River Bend Station - Unit 1

Docket No. 50-458

Enclosed is Gulf States Utilities Company's (GSU) response to the Safety Evaluation Report (SER) Confirmatory Item #16 (Section 6.2.3) regarding secondary containment pressure following a loss-of-coolant accident (LOCA). The analysis includes revised time delays for diesel start and fan speed-up. Although the time to reach the building design pressure increased, the dose analysis remains within the limits of 10CFR100.

The enclosed River Bend Station (RBS) Final Safety Analysis Report (FSAR) pages and figures have been revised to reflect the above analysis and will be incorporated in a future amendment.

FIGURE 6.2-61a

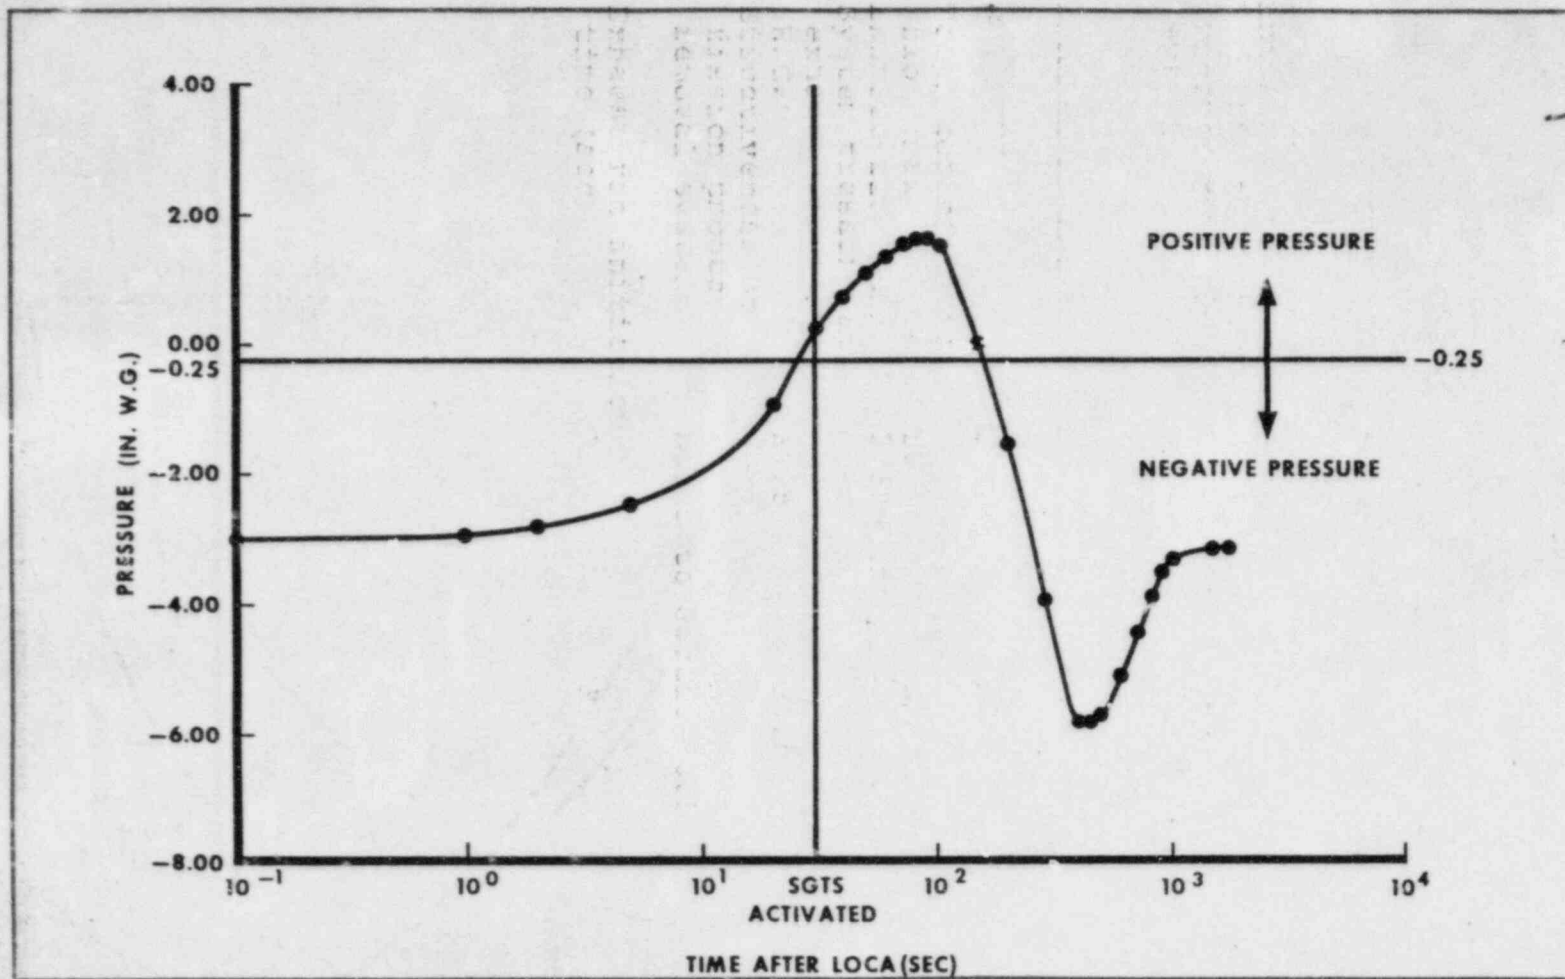
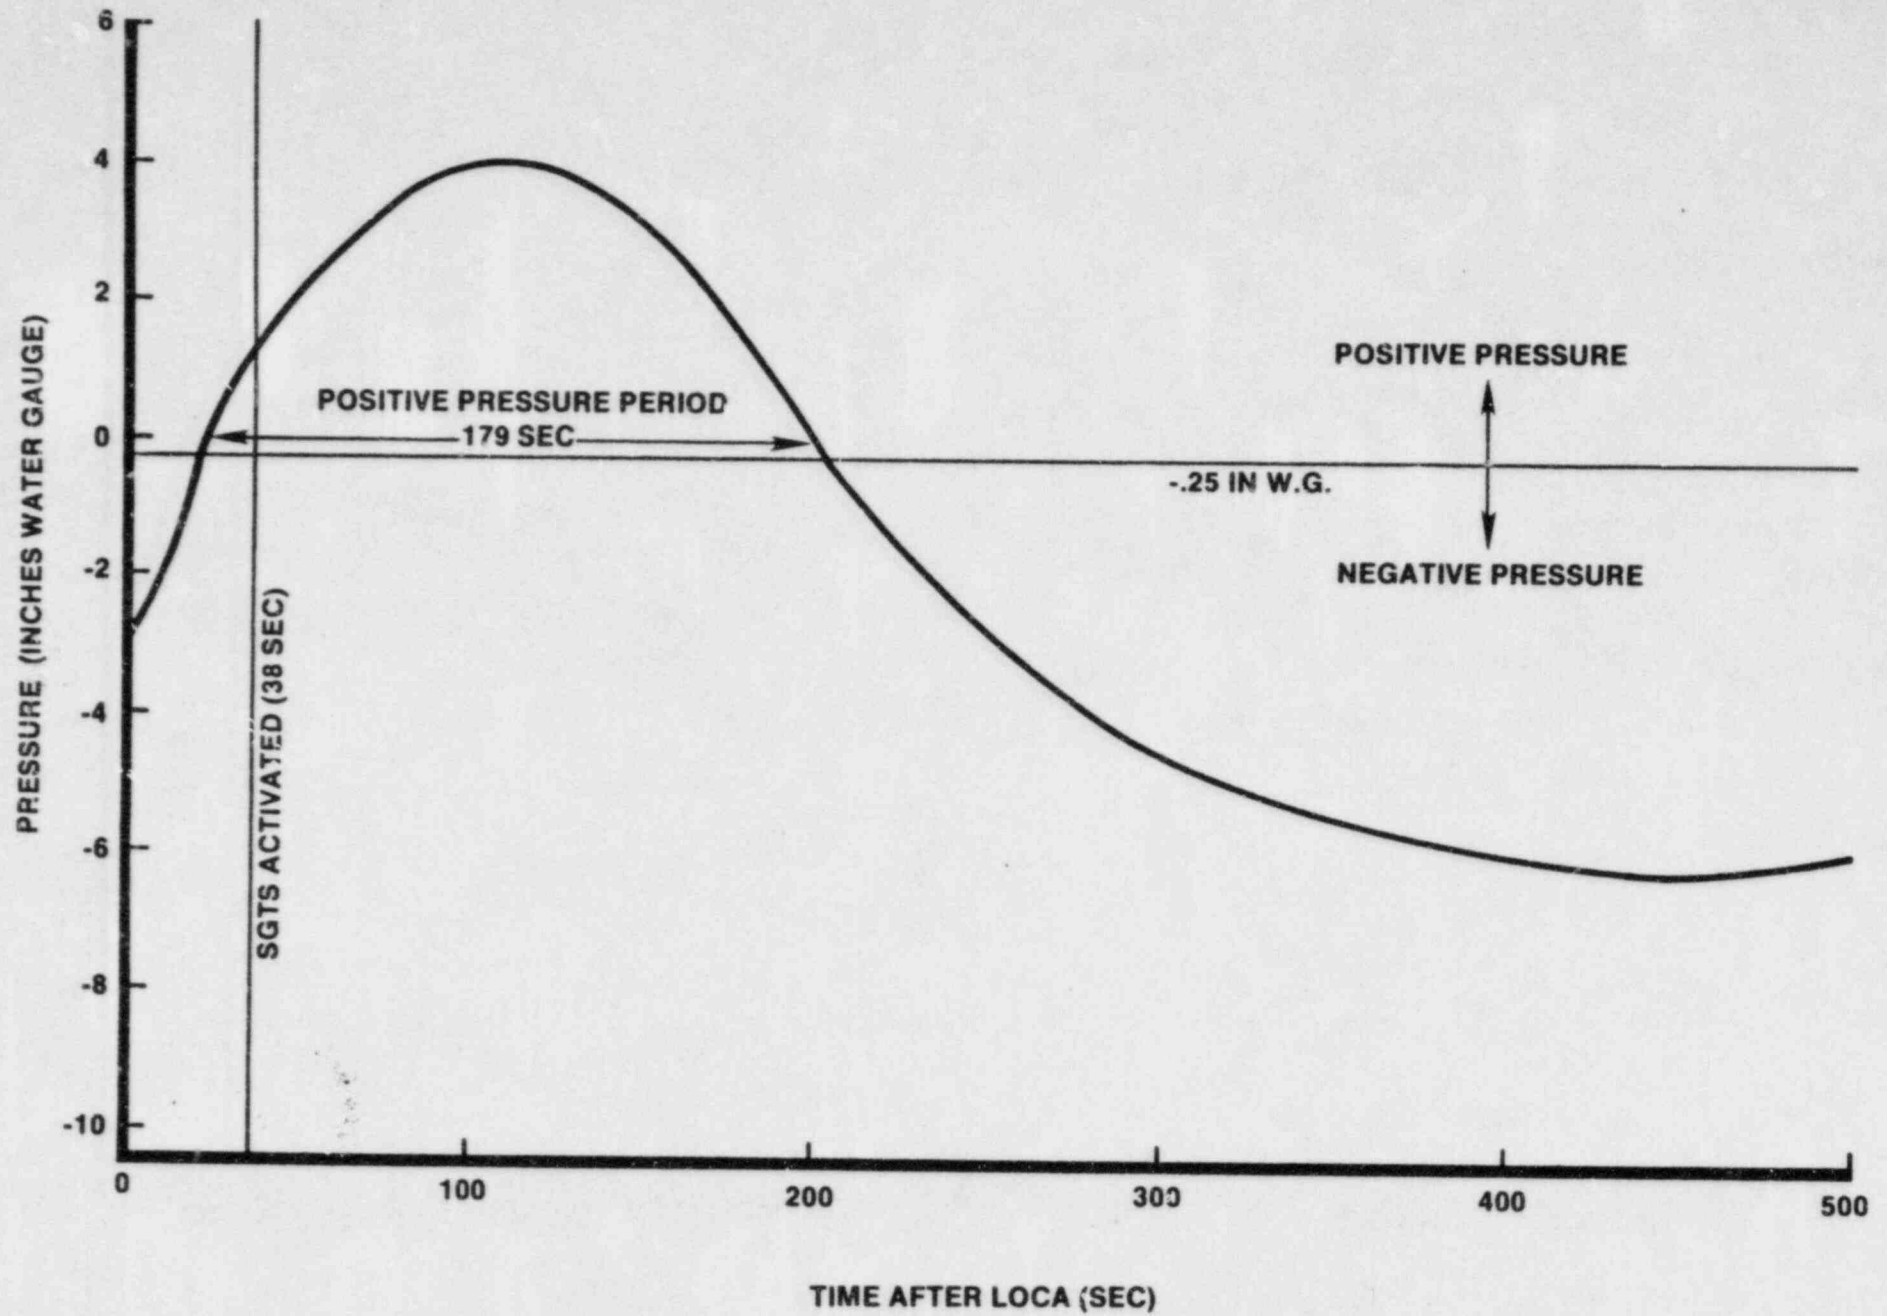
Fig. 6.2-61a indicates that there is a period following a LCCA during which a gauge pressure greater than -0.25 in

24 W.G. exists in the annulus. This period begins  
 approximately 25 sec after the LOCA and lasts for  
 179 approximately 135 sec. The dose rate analysis during this  
 period indicates that release of contaminated air from the  
 secondary containment is within the limits of 10CFR100.

DELETE AND  
REPLACE  
WITH  
INSERT

INSERT for Figure 6.2-61a

FIGURE 6.2-61b

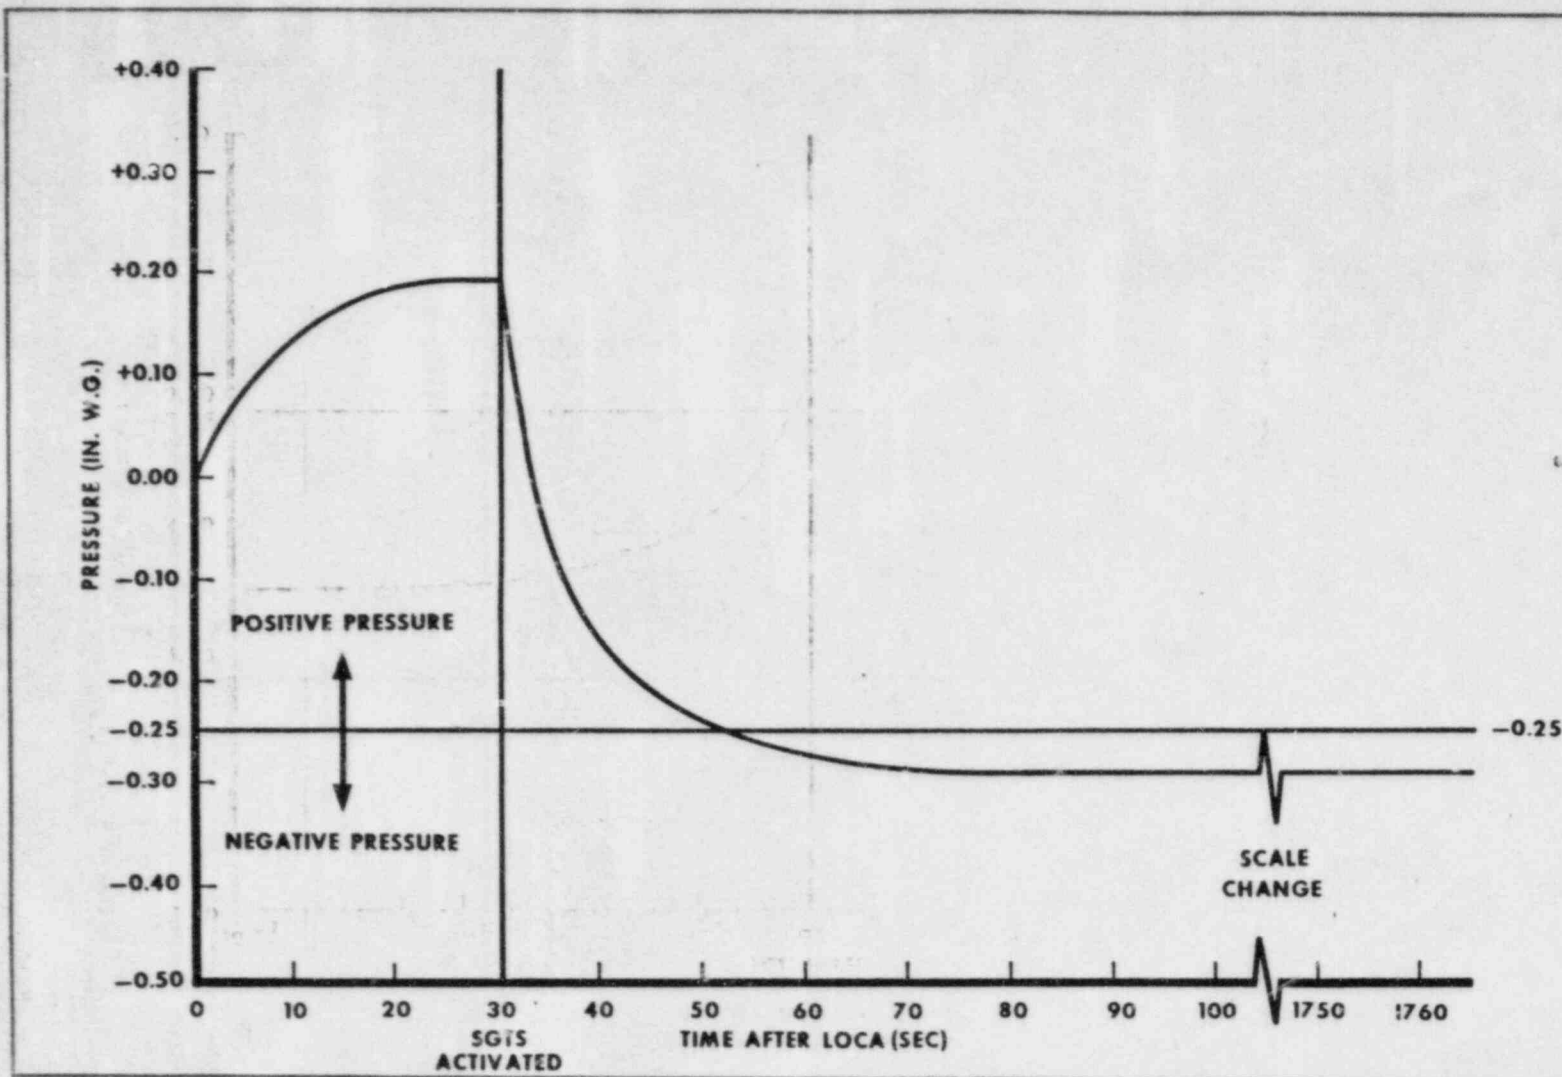
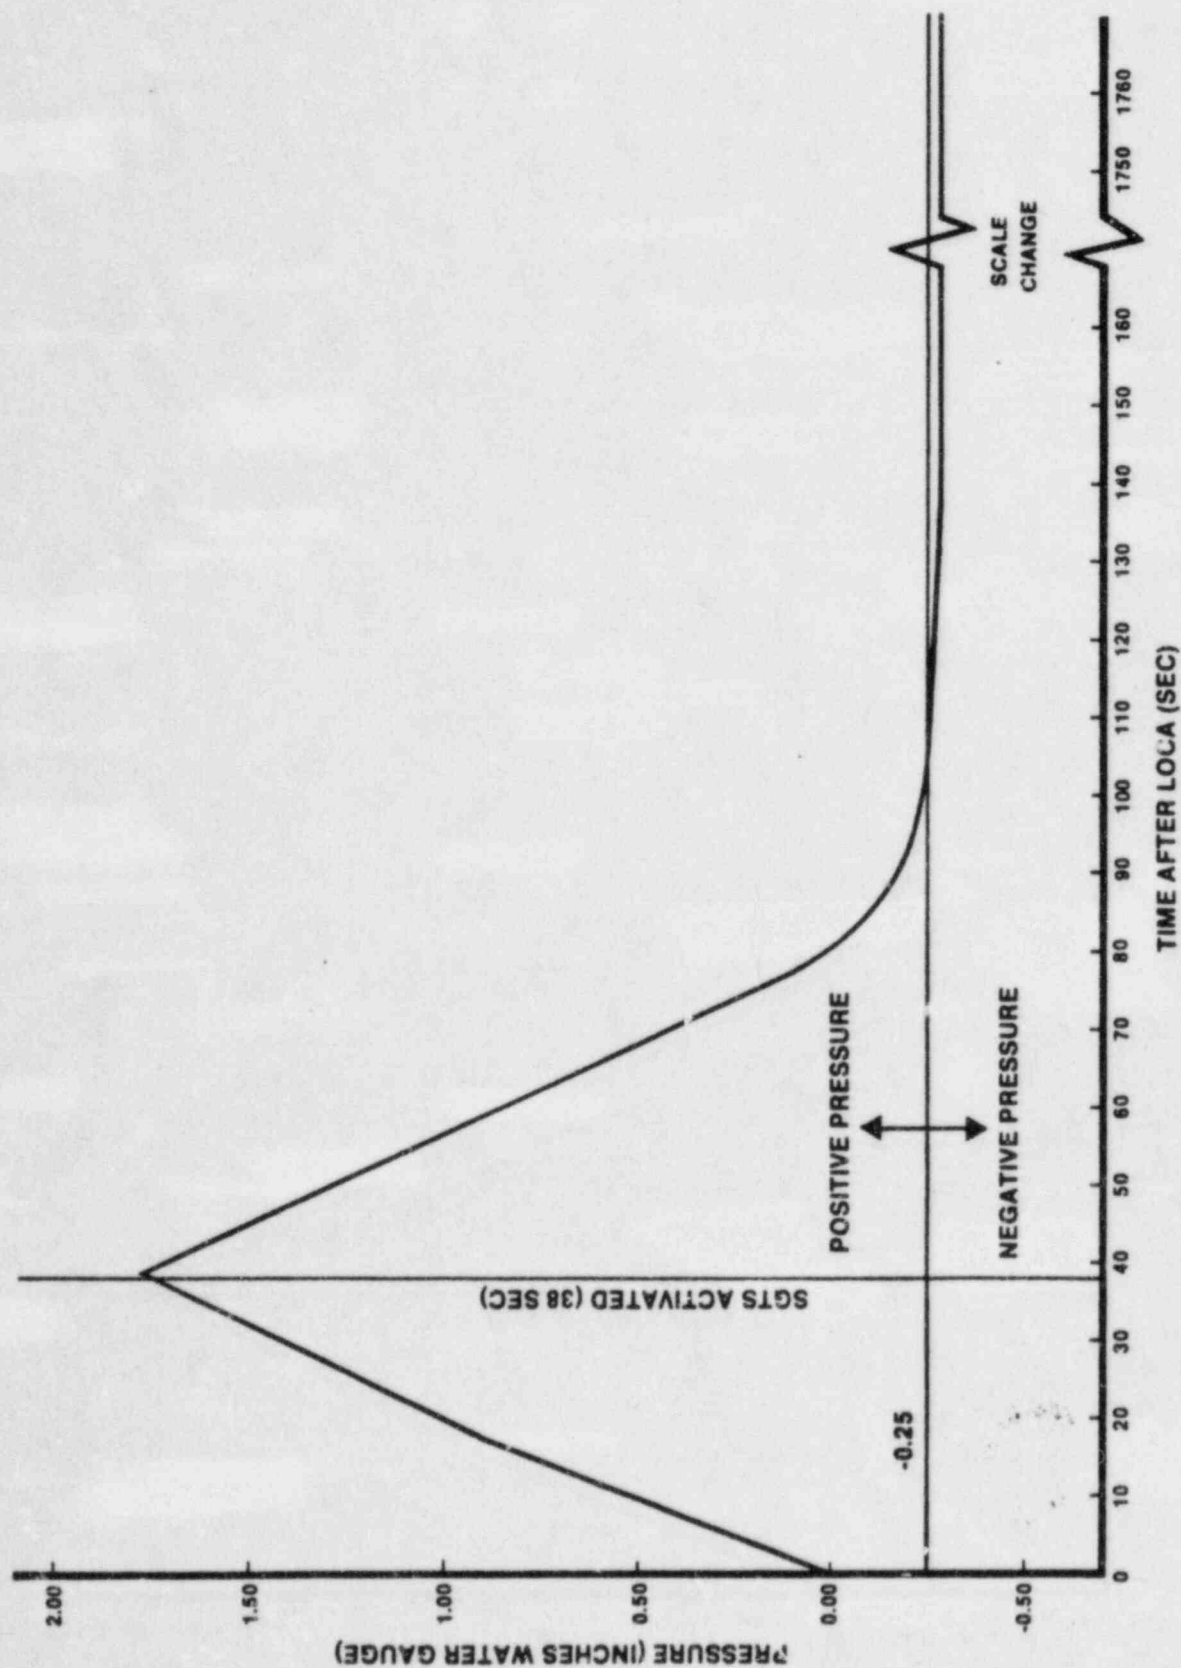
Results of the analysis of the annulus and the auxiliary building indicate that a pressure of -0.25 in W.G. is attained in 16.4 and 54 sec, respectively.

DELETE AND  
REPLACE  
WITH  
INSERT

INSERT for Figure 6.2-61b

FIGURE 6.2-62

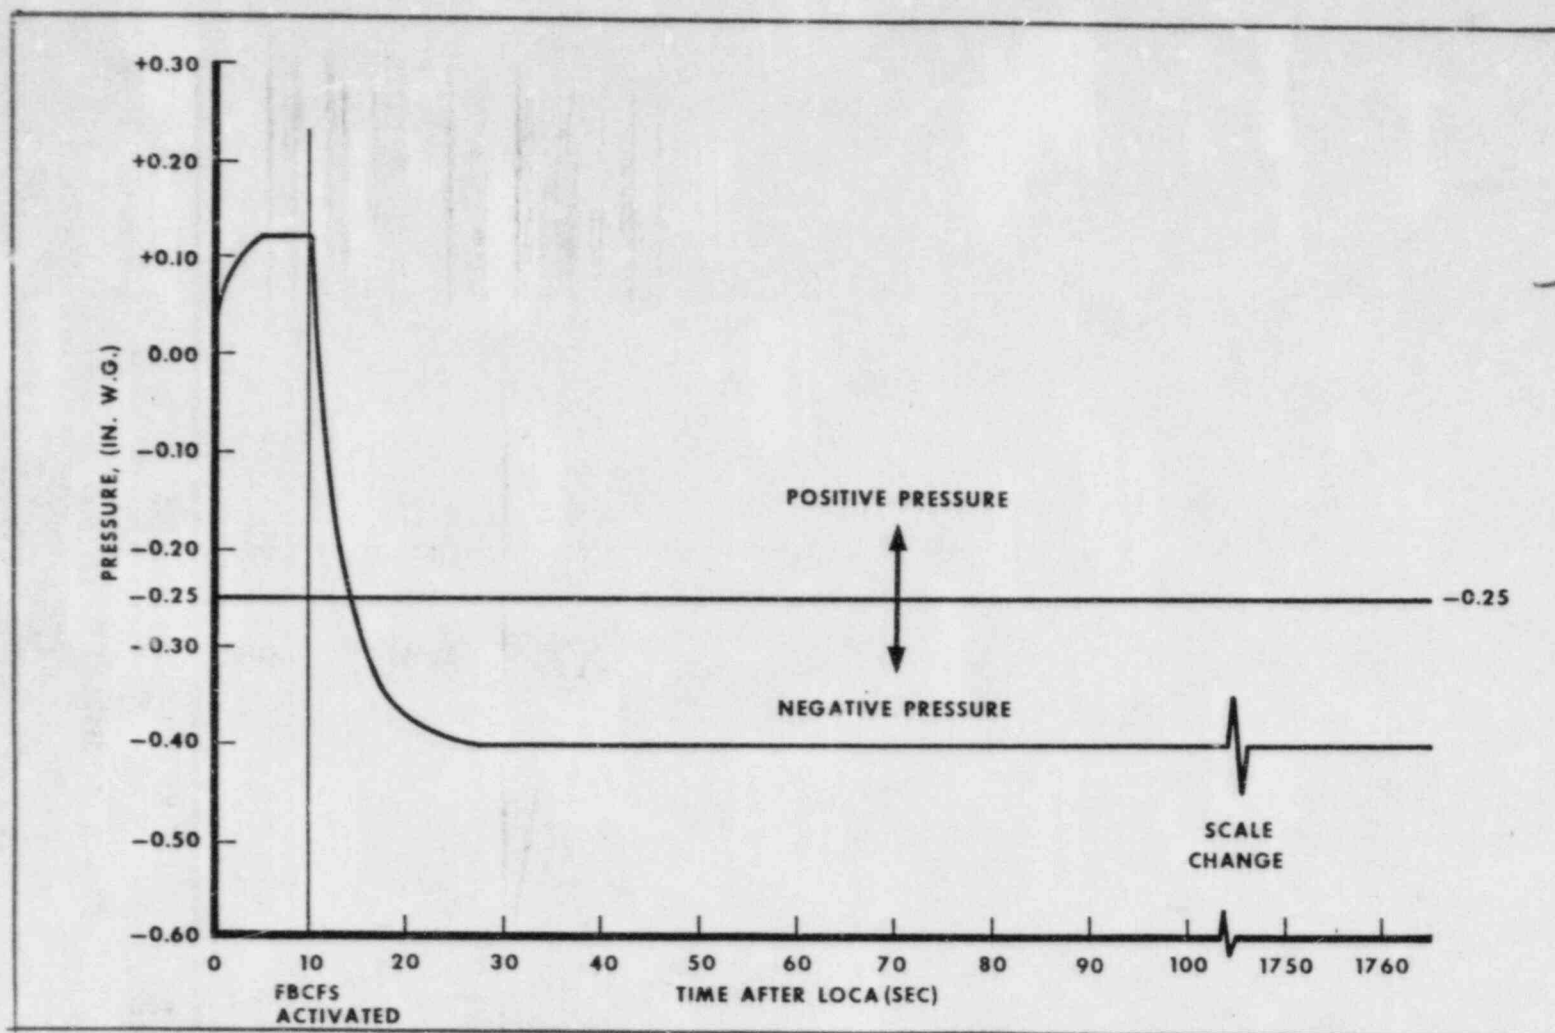
Results of the fuel building analysis indicate that a pressure of -0.25 in W.G. will be attained in 14.5 sec.

DELETE AND  
REPLACE  
WITH  
INSERT

INSERT for Figure 6.2-62
